DRAWING AMENDMENTS

REMARKS

The Office Action mailed 06/14/2005 states that:

FIG. 1

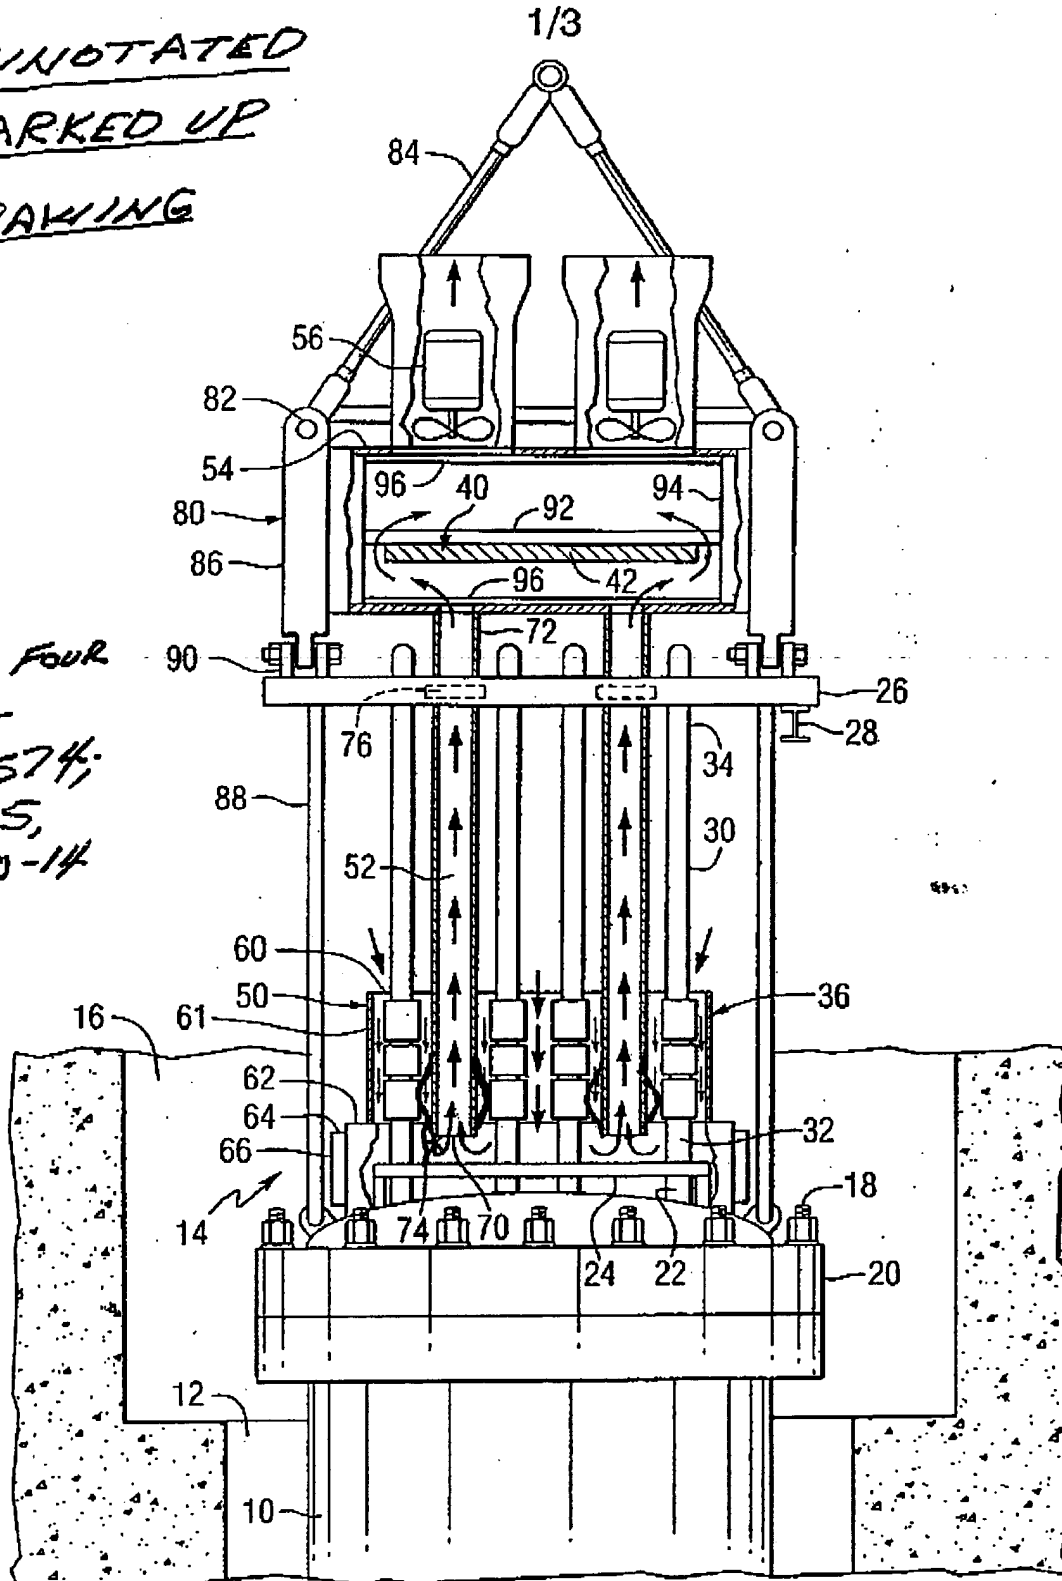
(c) The drawings were objected to under 37CFR 1.83(a) for the stated reason that they do not show support springs 74 as described by Claims 2 and 3 and internal ducts seismically supported as described by Claim 4. See Paragraph 4 on Pages 3-4 of the Office Action.

The Examiner pointed out that the drawings do not show the "resilient spring 74" described in the description at page 5, lines 10-12, as "a narrow deformed length of the internal duct 52" which supports the lower end 70 of the duct 52 against the coil stack assemblies 36.

ADDED FOUR
RESILIENT
SPRINGS 74;
SEE PAGES
5, LINES 10-14

Please replace the current Figures 1 and 3 (that were examined 6/14/2005) with the following Replacement Figures 1 and 3. These drawing figures have been amended at four locations to indicate "springs 74" at the lower ends of "internal ducts 52". An explanation of the changes is incorporated into the following Remarks section of this Reply. A marked up copy of current drawing Figures 1 and 3 indicating the changes is attached to this Reply as Appendix A.

The Applicants have amended Figures 1 and 3 to show the lower ends of ducts 52 having deformed lengths or springs 74 (as recited by Claim 2) supported by adjacent coil stack assemblies 36 (as recited by Claim 3).

FIG. 4

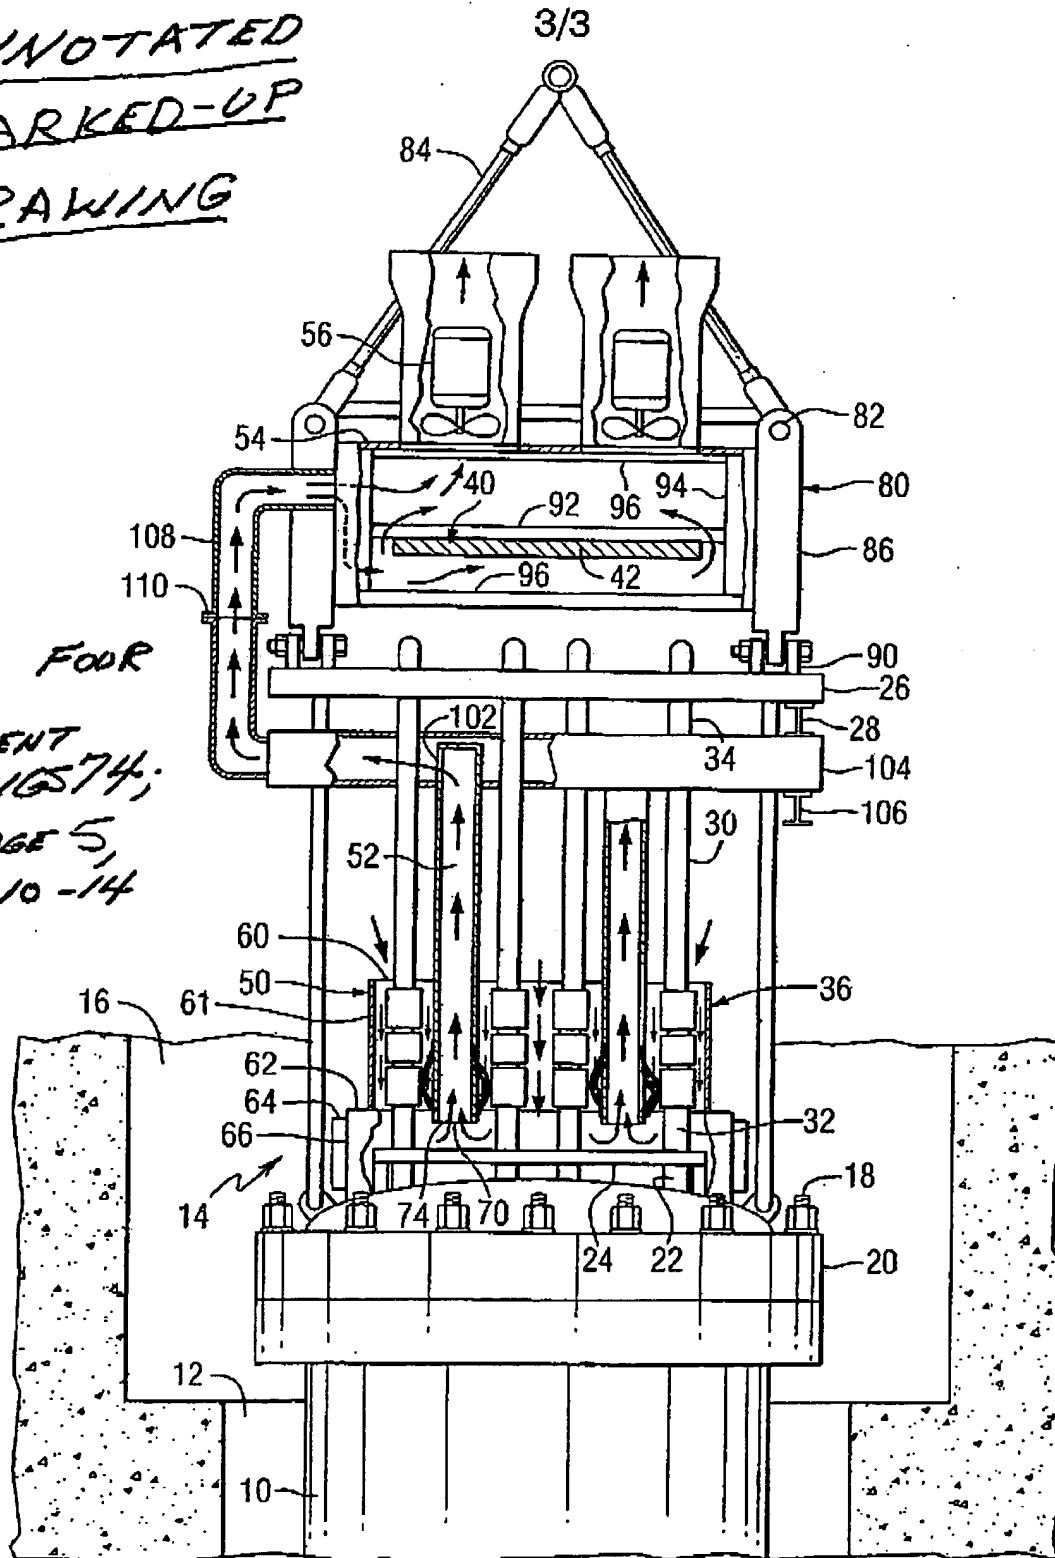
ADDED FOUR
RESILIENT
SPRINGS 74;
SEE PAGE 5,
LINES 10-14
